## CHANGE ORDER NO. 3

<b>PROJECT:</b>	Water Reclamation Facility Improvements	<b>DATE OF ISSUANCE:</b>	September 18, 2020
<b>OWNER:</b>	City of Rochelle, Illinois	<b>ENGINEER:</b>	Baxter & Woodman, Inc.
<b>CONTRACTOR:</b>	Whittaker Construction & Excavating, Inc.	<b>ENGINEER'S PROJECT:</b>	171097.60

Water Reclamation Facility Improvements

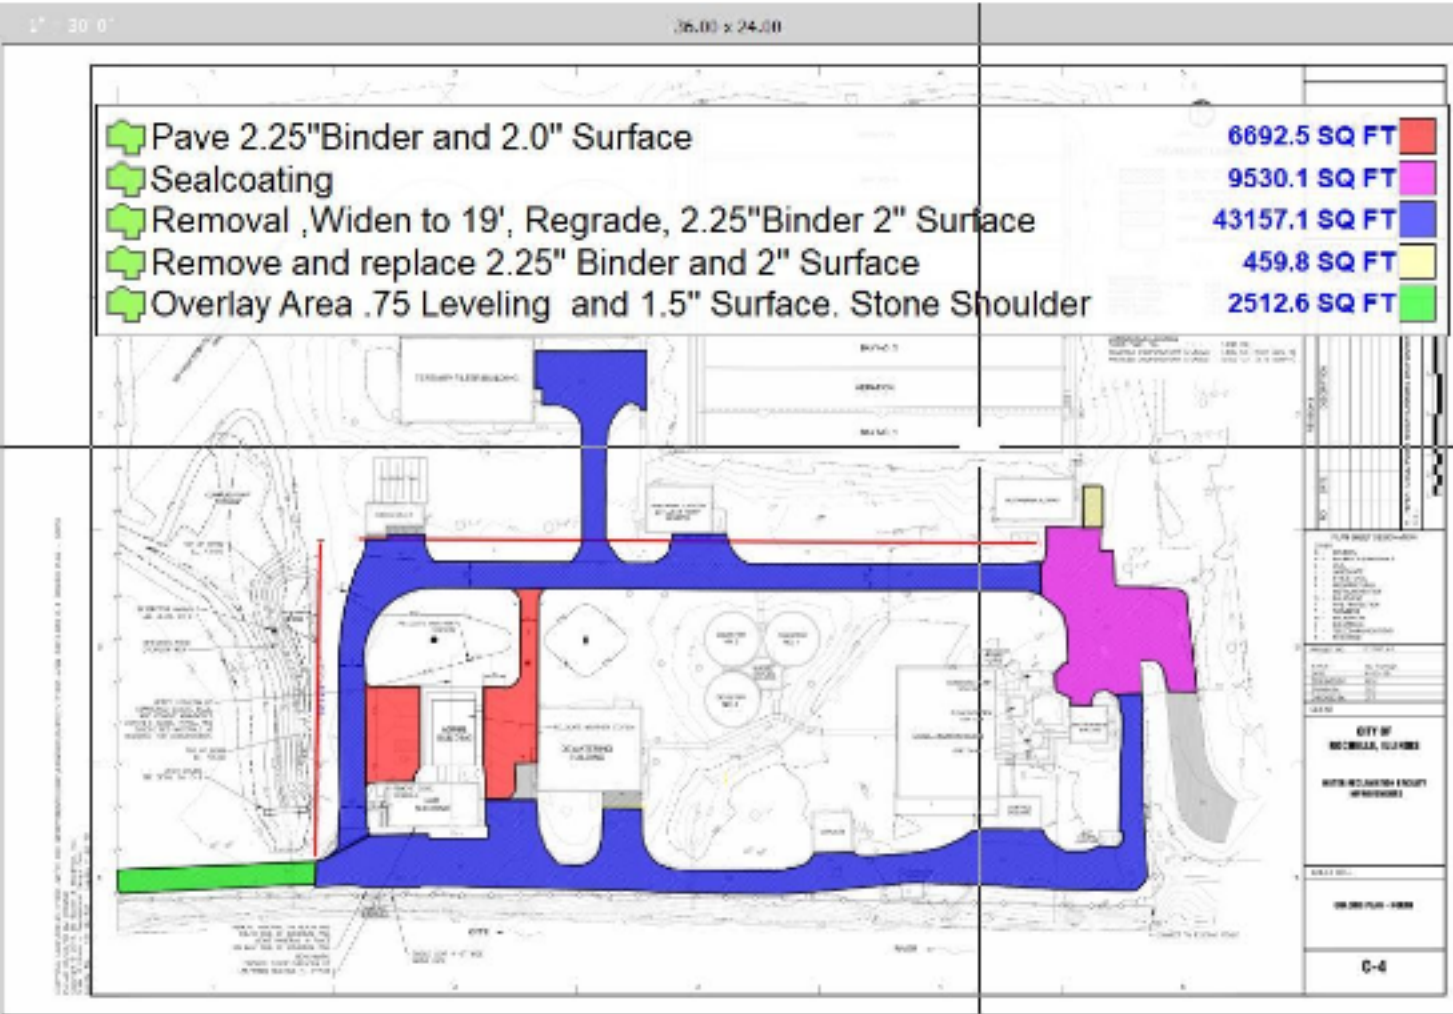
Qty	Proposed Service(s) & Description(s)	Depth
43157 Sq. Ft.	Final Grading Blue Area  <b>Service Description</b> <i>200 Tons of Stone is included with bid. Final grade existing aggregate and compact. If additional aggregate base is required to achieve sub grade an additional charge of \$14.00 per ton. Core out of existing aggregate base course is excluded. If undercutting is required, it will be done at the additional cost of \$65/c.y. Repairs to any unmarked lines (irrigation, site electrical, etc.) are excluded. Storm sewer work is excluded. Parking lot will be reshaped to follow existing drainage patterns. Permit fees and testing and/or construction inspection fees are excluded.</i>	\$13,553.81
43157 Sq. Ft.	Milling Blue Area  <b>Service Description</b> <i>Full Depth Milling of asphalt and haul off site. Clean and sweep loose debris. Core out of existing aggregate base course is excluded. If undercutting is required, it will be done at the additional cost of \$65/c.y. Repairs to any unmarked lines (irrigation, site electrical, etc.) are excluded. Permit fees and testing and/or construction inspection fees are excluded.</i>	\$22,900.00

43157 Sq. Ft.	Commercial Paving Blue area  <b>Service Description</b> <i>Belrock to verify final grade prior to installing HMA pavement. Install 2.25" HMA Modified Binder pavement, and 2.0" HMA Modified Surface pavement in (2) lifts. Prime coat and tack coat are excluded from bid. Pavement striping, wheel stops, signs etc. are excluded. Permit fees and testing and/or construction inspection fees are excluded.</i>	\$115,832.40

6700 Sq. Ft. Commercial Paving ----- Red Area \$20,383.46

9600 Sq. Ft. Commercial Paving Green Area \$22,374.73

9530 Sq. Ft. Extreme Seal----- Purple Area \$2,795.20

MARK: PRE-6
PROJECT: ROCHELLE WWTP
DATE: 8/24/2020

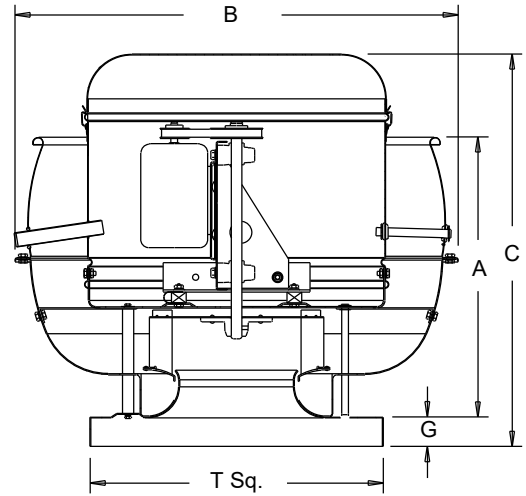
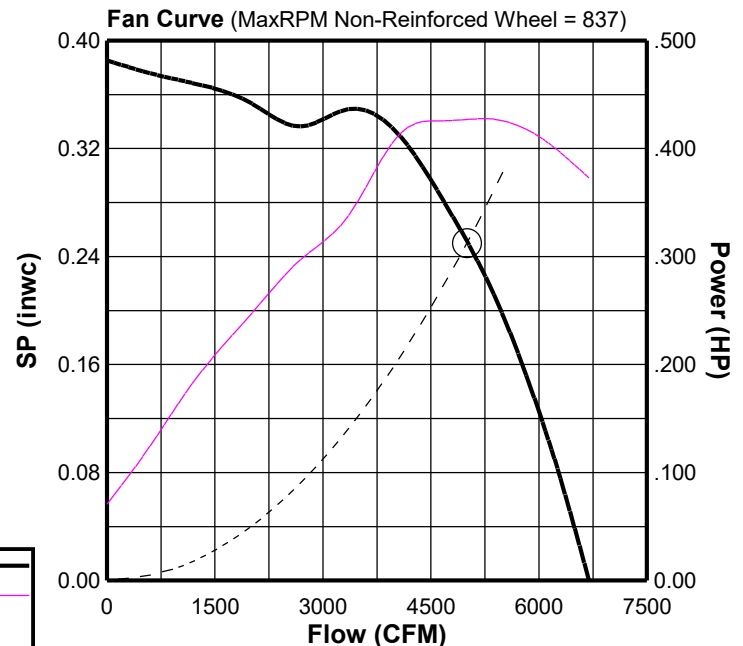
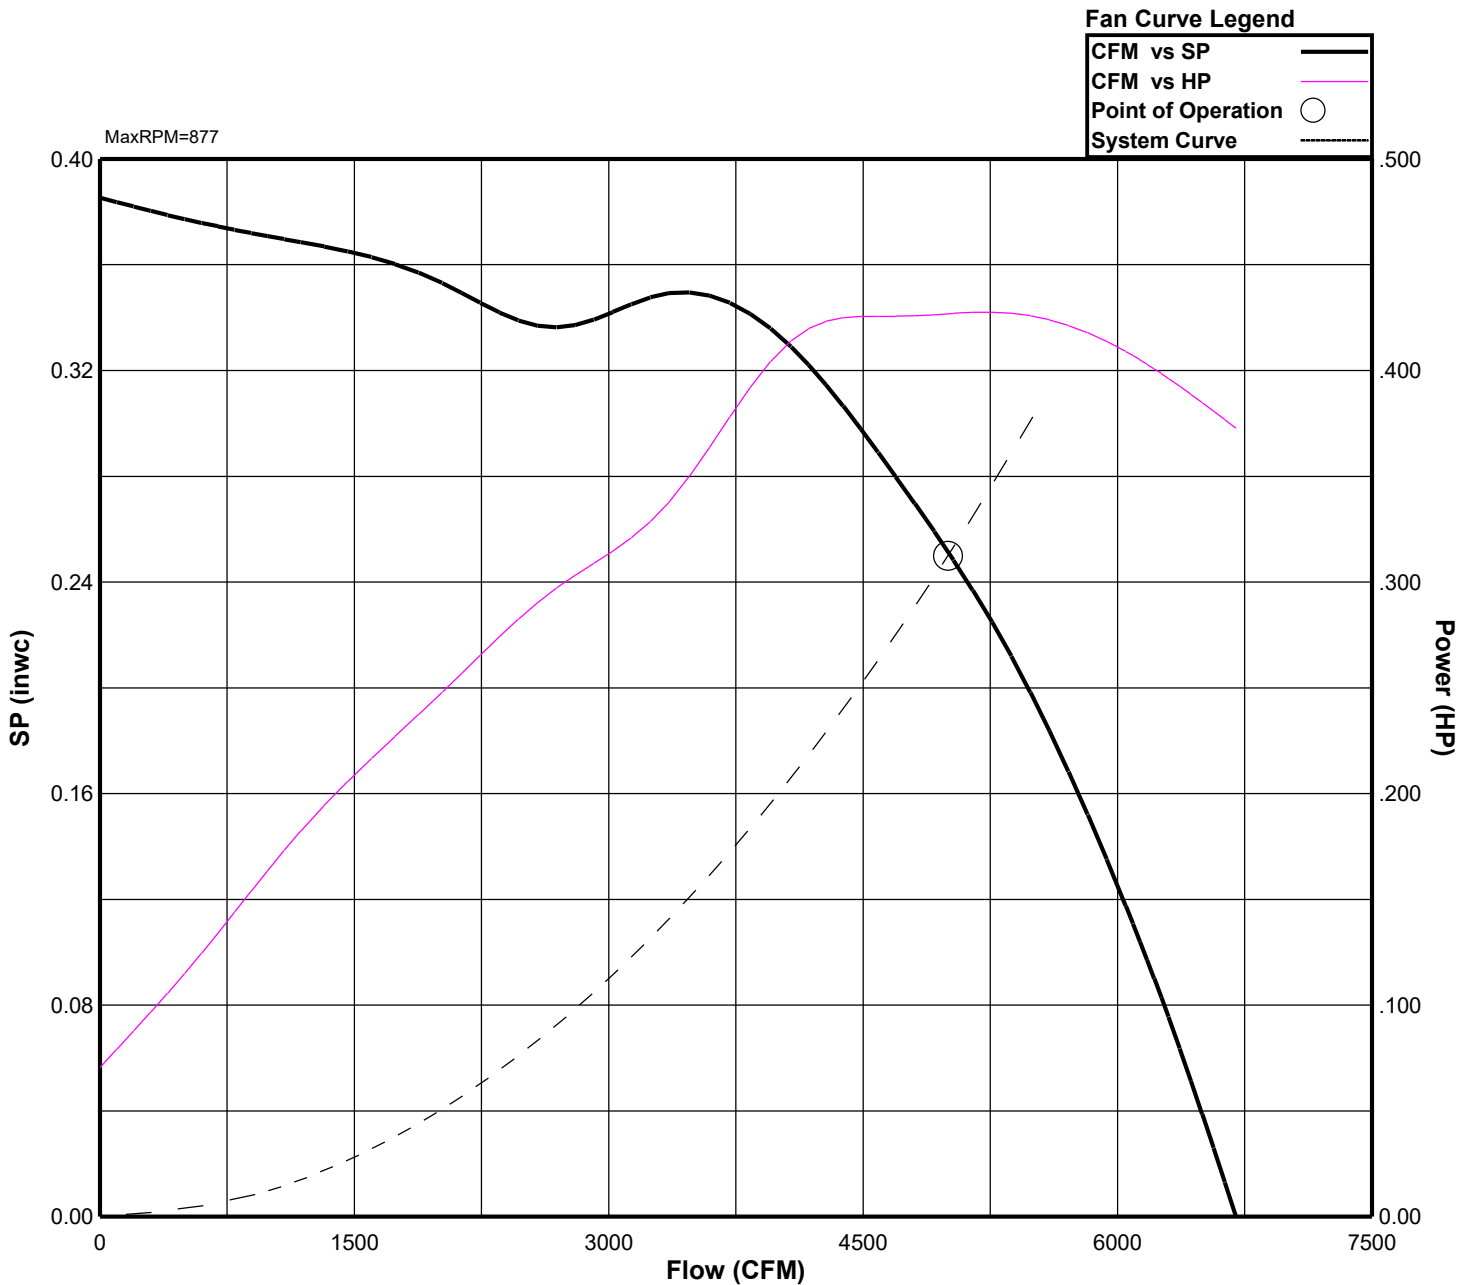
**DESCRIPTION OF CHANGE:** Replace existing fan.

We propose to furnish labor and material to replace an existing Cook fan with a new Fan. Our price includes the following:

Remove existing fan  
Install new fan and gravity damper on existing curb  
Start up  
Test and balance  
Hoisting
